Ref. No.A9021.02Subject:Lake Worth – Operating Permit Application for Class 1 Injection Well and Dual<br/>Zone Monitoring Well System, Permit No. 0297969-002-UO

The purpose of this letter is to provide a response to the Departments request for information (RFI) dated August 22, 2012 related to an operating permit application for deep injection well IW-1 at the City of Lake Worth Water Treatment Plant. For ease of review, each RFI question or comment is provided below in italics, with the response immediately following.

Figures 1 through 7

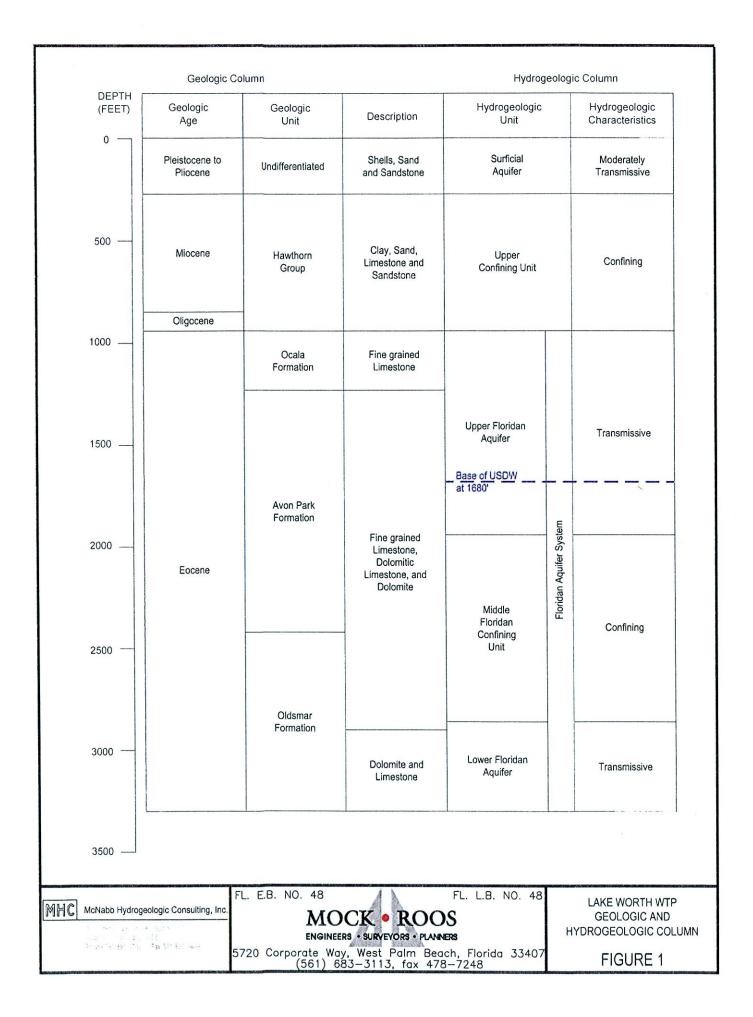
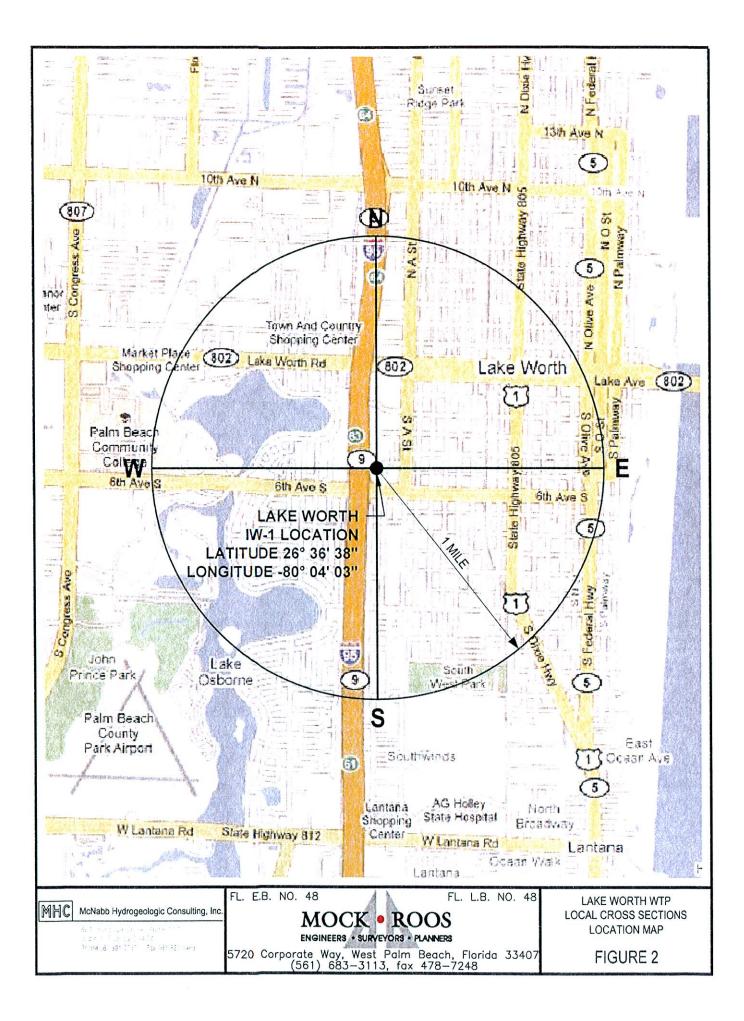
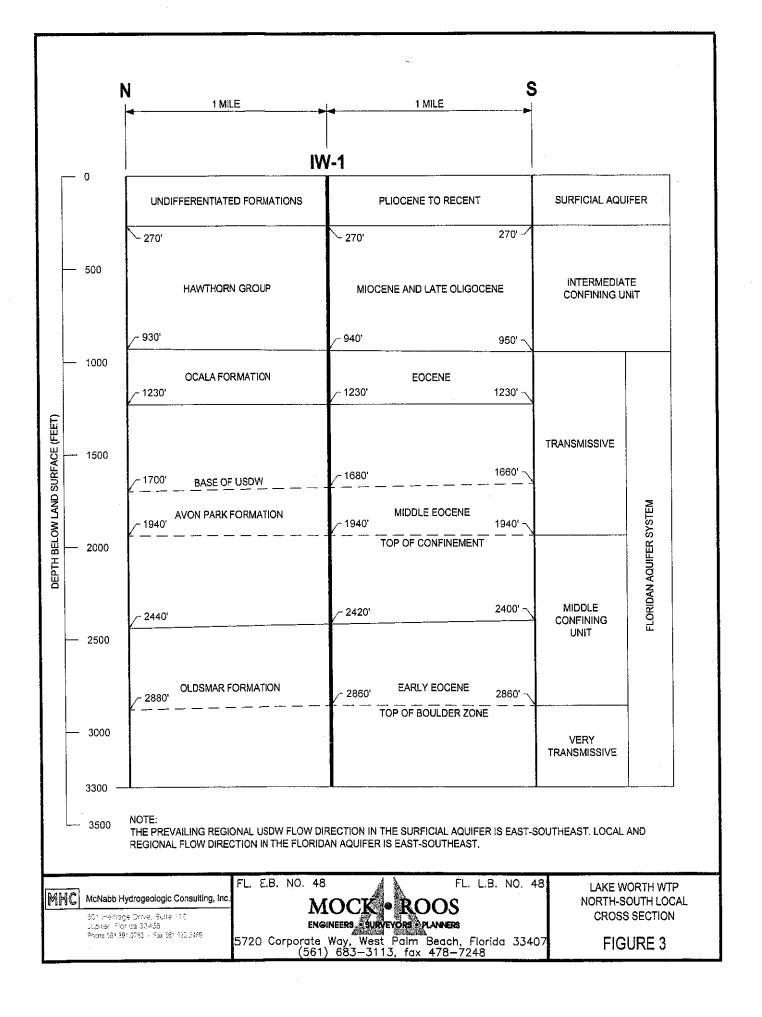
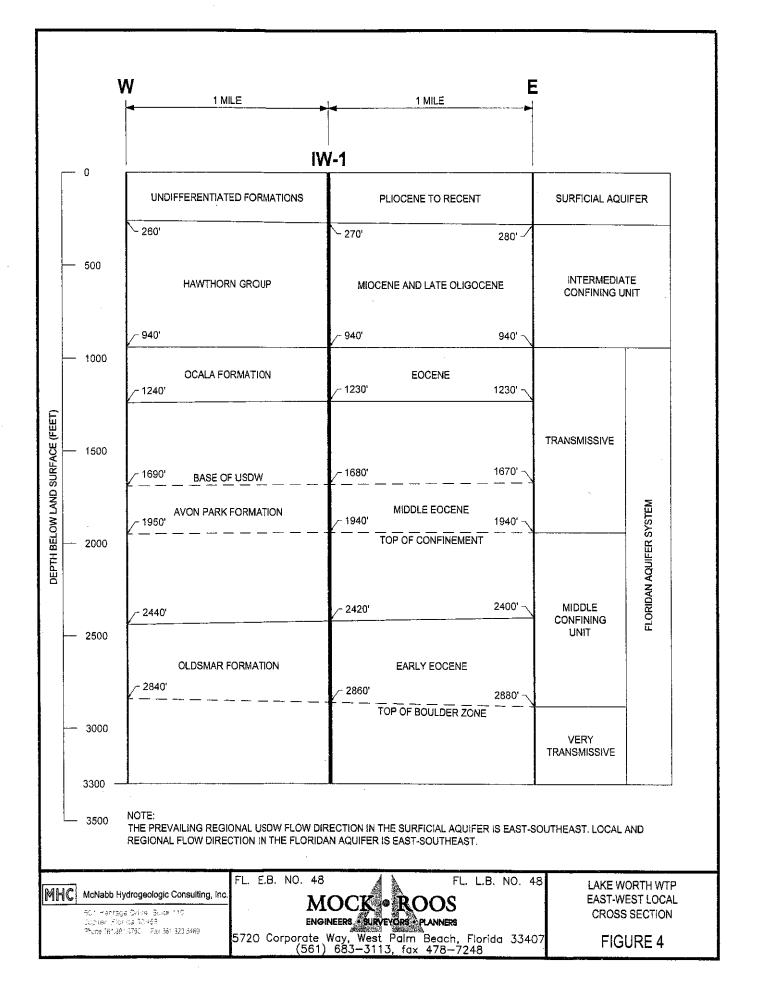
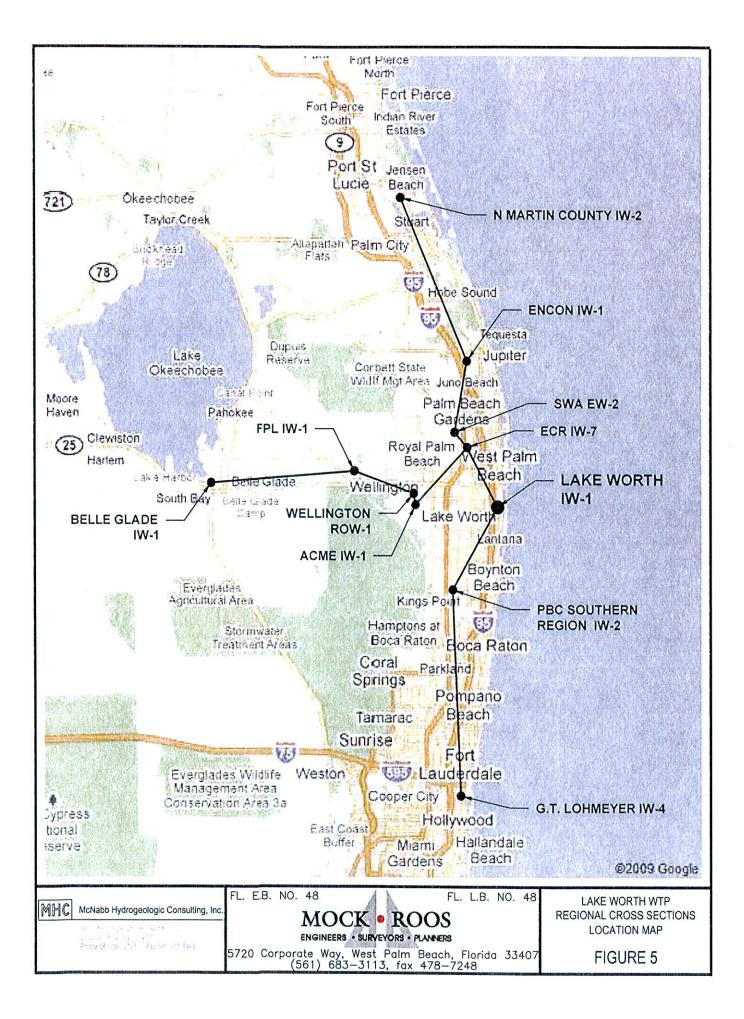
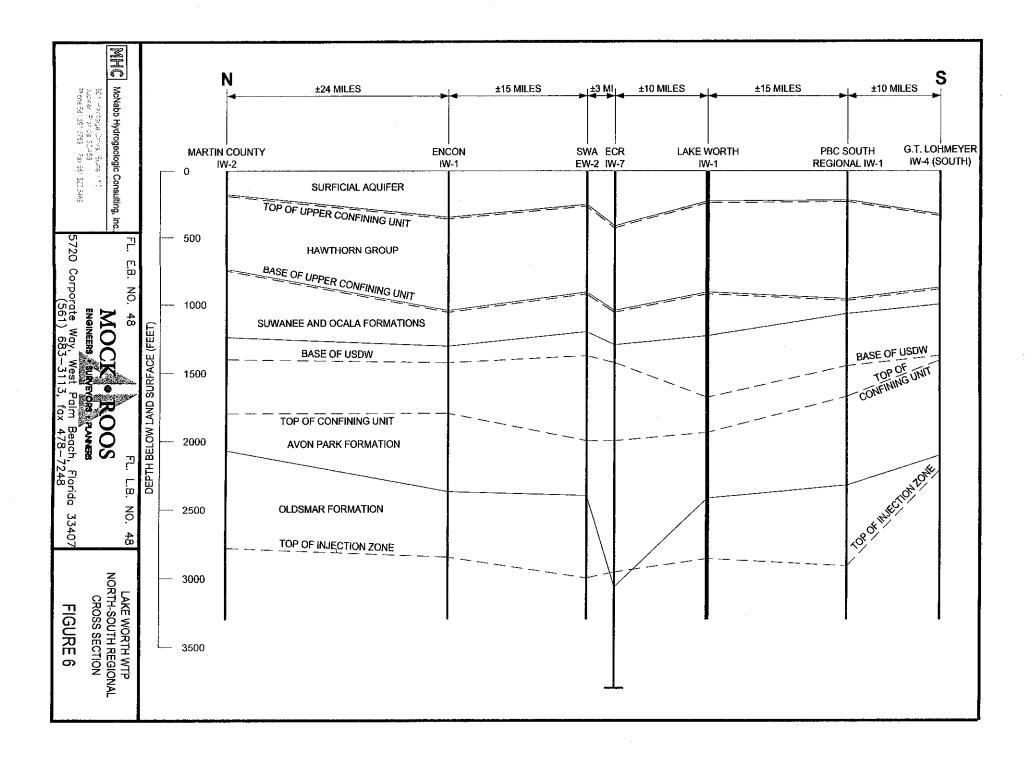
1. The application should include the cross section figures that are referenced for the regional deep injection wells and provide details of the area geology and hydrogeology. Please include this information in the application.

**Response**: Data collected during construction of IW-1 were used to prepare the geologic and hydrogeologic column for the IW-1 presented in Figure 1. Interpretation of data collected during construction and testing of IW-1 indicates that the Surficial Aquifer is present at the site to a depth of approximately 270 feet below land surface (bls). The confining strata of the Hawthorn Group separating the Surficial Aquifer from the Floridan Aquifer are present from approximately 270 to 940 feet bls at the site. The base of the Underground Source of Drinking Water (USDW) was identified at a depth of 1,680 feet bls. The primary confining unit separating the base of the USDW from the injection zone is present from approximately 1,940 to 2,860 feet bls. The injection zone is present from a depth of 2,860 feet bls to the total depth of the well at 3,303 feet bls. Figure 2 provides a local cross section location map. Figures 3 and 4 provide geologic and hydrogeologic cross sections for the site. Figure 5 provides a regional cross section

location map. Figures 6 and 7 provide regional geologic and hydrogeologic cross sections for the site.

**Updated Record Drawing Sheet C1-2**

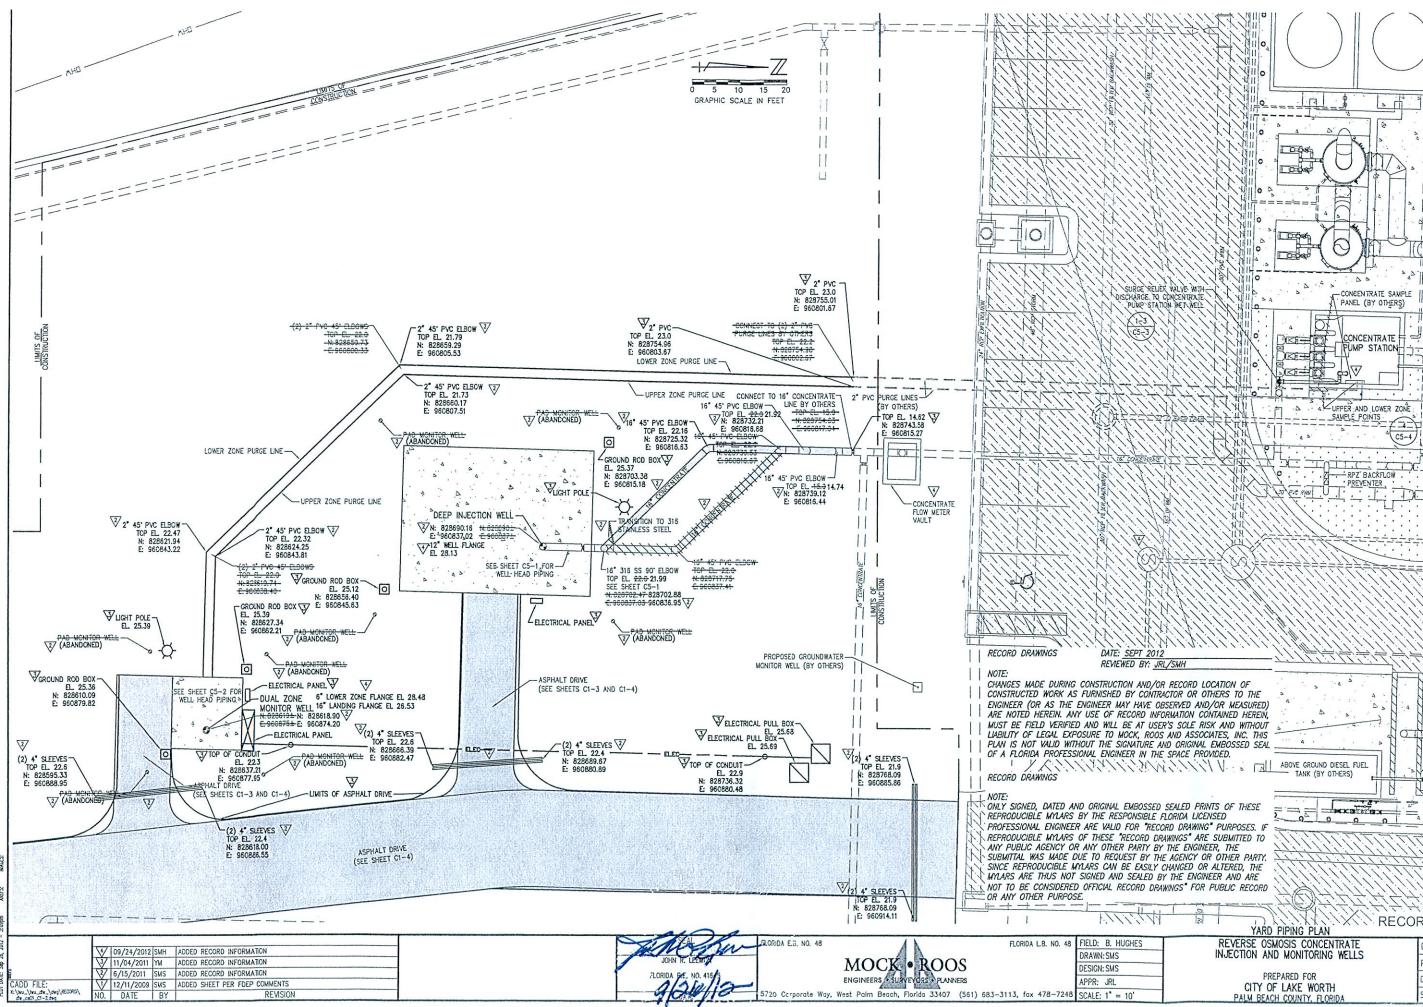
5. In reference to the engineer's drawing, Sheet C1-2, dated June 29, 2011, the drawing shows a shaded out area on the drawing (see attached). The concern is the "16-inch concentrate" lines going to the injection well. At the location of the wet well on the drawing, below the wet well, is a 16-inch tee and valve going to the wet well and from the pumps a 16-inch tee going back into the 16-inch concentrate line to the injection well. Also, between these two tee connections is a connection to the 30-inch PVC RWM.

Further along the 16-inch concentrate line going to the injection well is an unidentified box structure and to the left is another 16-inch tee and valve connection (see attached drawing).

Please provide the Department with the signed and sealed drawing of these structures and installation and the reason for the by-pass valves and tee structures.

**Response**: In reference to the questions on drawing C1-2 the following explanations are provided:

The shaded or hatched areas generally represent areas to be paved. The concentrate flow from the reverse osmosis (RO) plant is normally discharged to the concentrate pump station wetwell. For alternate operations the concentrate flow may bypass the concentrate pump station and be piped directly to the deep injection well. Note that this method of operation is not normally recommended, but is available if needed.

The 30-inch PVC raw watermain furnishes raw water from the Floridan wells to the RO plant. When the Floridan wellfield is out of service for an extended time period, it must be flushed extensively prior to furnishing raw water to the RO plant. This was the case with the Floridan wells when the RO plant was ready to startup in July 2011. The wells were flushed to tide under a general permit to discharge formation fluids. This connection is protected by a RPZ backflow preventer. The piping is located below ground where as the RPZ backflow preventer and associated isolation valves are located above ground for routine inspection, testing, and annual certification.

The box in question and several other items were not labeled because they were not in the construction contract for the deep injection well. Instead, they were in the construction contract for the reverse osmosis plant. The box is the concentrate flow meter vault that houses the magnetic flow meter for the concentrate flow and has been so labeled on the drawing.

The tee and valve connection located just south of the concentrate flow meter vault is to route the raw Floridan waters to discharge for flushing the Floridan wells as discussed above. A signed and sealed updated record drawing copy of sheet C1-2 with the above labels added is attached. Reference Sheet C1-2, Drawing No. 44-43-28-288 dated October 2009, last revised September 2012.
